LiDAR Quality Assessment Report

AK_BrooksCamp_2012

Brooks Camp, AK Ortho/Lidar

**Brooks Camp AK Ortho/Lidar Task
checkpoint layout**

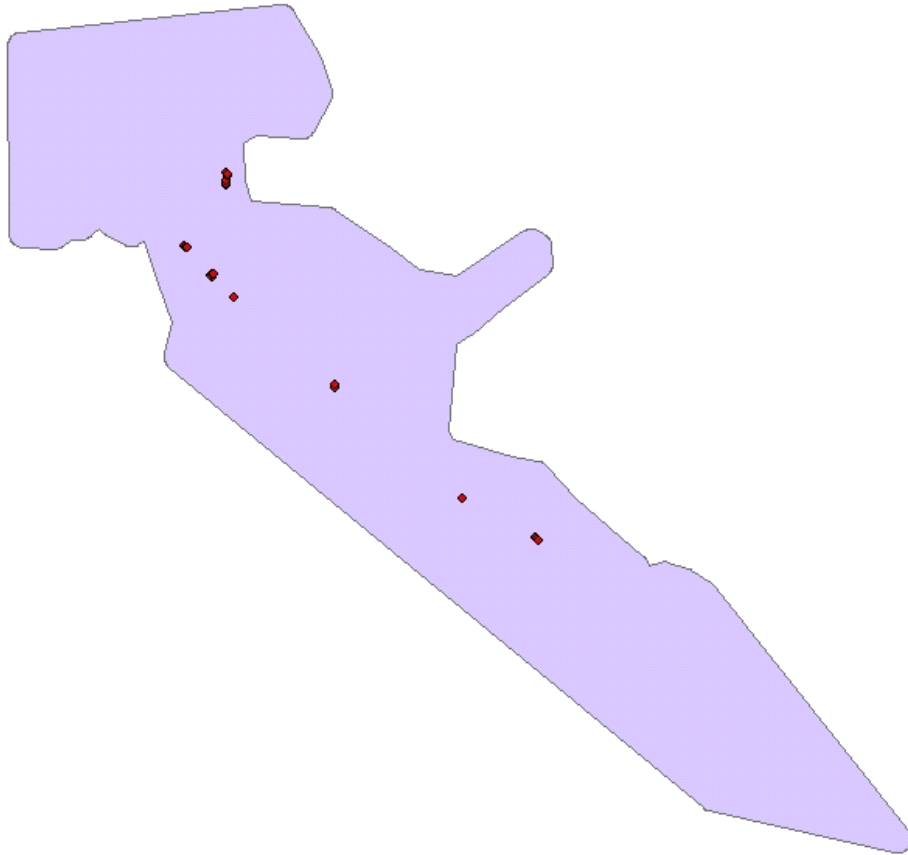
There are a minimum of 20 checkpoints for each land cover class represented. Points within each class are uniformly distributed throughout the dataset. USGS was notable to locate independent checkpoints for this analysis. USGS does not accept at this time the quality of the checkpoint data for these LiDAR datasets.

The lack of well-dispersed control checkpoints may be due to the fact that this project area is also grizzly bear habitat and could be considered hazardous to human intervention.

Further examination of the checkpoint distribution shows limited areas of open, flat terrain. This may also explain the "clumping" of the checkpoints. Looking at imagery and lidar, as well as creating buffers around breaklines, it is the opinion of the NGTOC that there were additional open, flat, terrain areas where independent checkpoints could have been collected, increasing the distribution of the checkpoints.

The NGTOC did a calculation of FVA on the delivered swath las files. The RMSE(z) was 0.032 meters, the Accuracy(z) at 95th CI was 0.063 meters. While this vertical accuracy does pass, these checkpoints are not well distributed throughout the dataset. There are other areas of what appear to be open, flat terrain across this project where checkpoints could be collected to create a better distribution.

While the distribution of checkpoints is not good, these will be accepted due to the nature of the geographic hazards of this area. This was verified in a conference call with Tim Saultz, Pat Emmett, and Deb Cochran on Friday October 14th 2012.

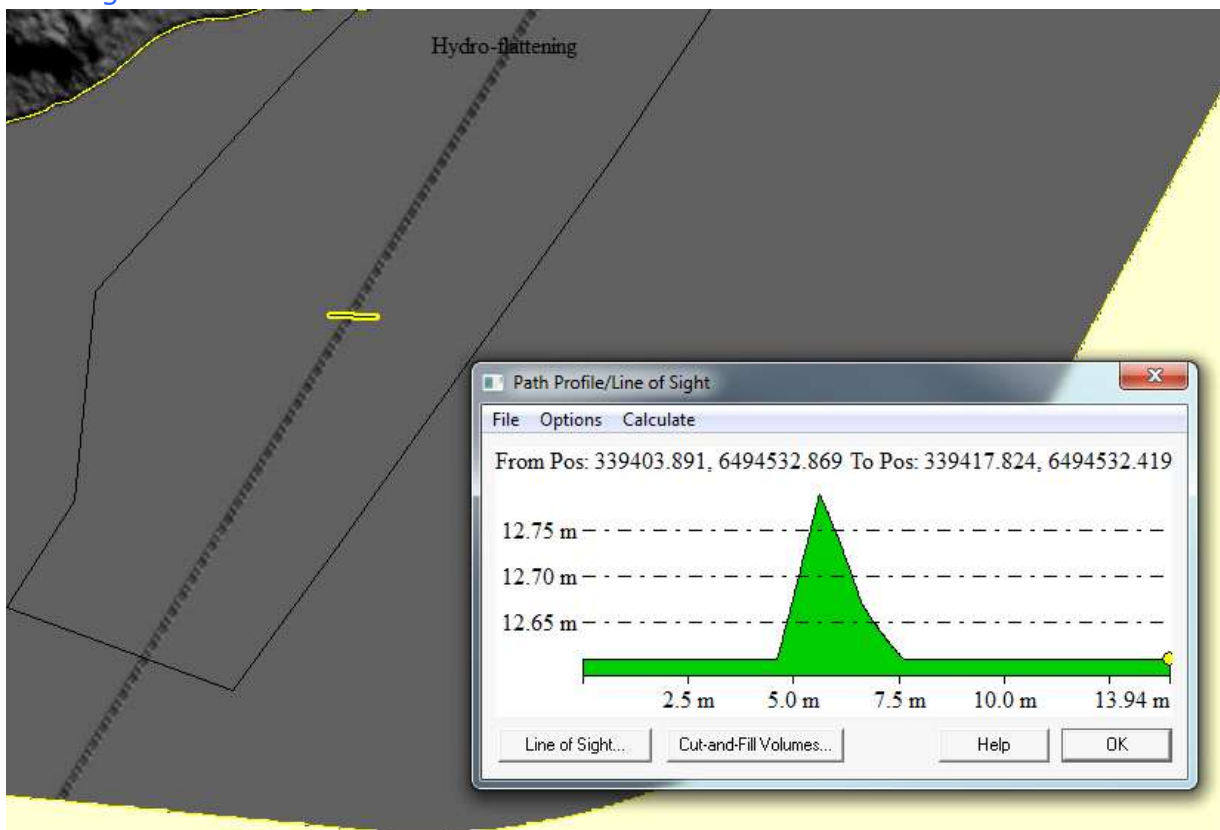
10/15/2012: This water feature at the boundary should be flat, however there is an artifact that is causing a ridge in the surface. This should be corrected. All instances of this occurrence are georeferenced in the delivered shapefile.

10/15/2012: The breakline is covering bare earth. Additionally, there is an island that is not shown when hydro-flattening occurs because there is not a breakline around it. This island should show in the DEM, and the breakline should be closer to the shoreline.

10/15/2012: This breakline appears to be randomly placed. Breaklines should be continuous across surface.

10/15/2012: This breakline is covering bare earth. The breakline should be set closer to the actual shoreline to preserve bare earth surface.

12/11/2012: All hydro-flattening and breakline issues have been corrected. The breaklines are accepted.
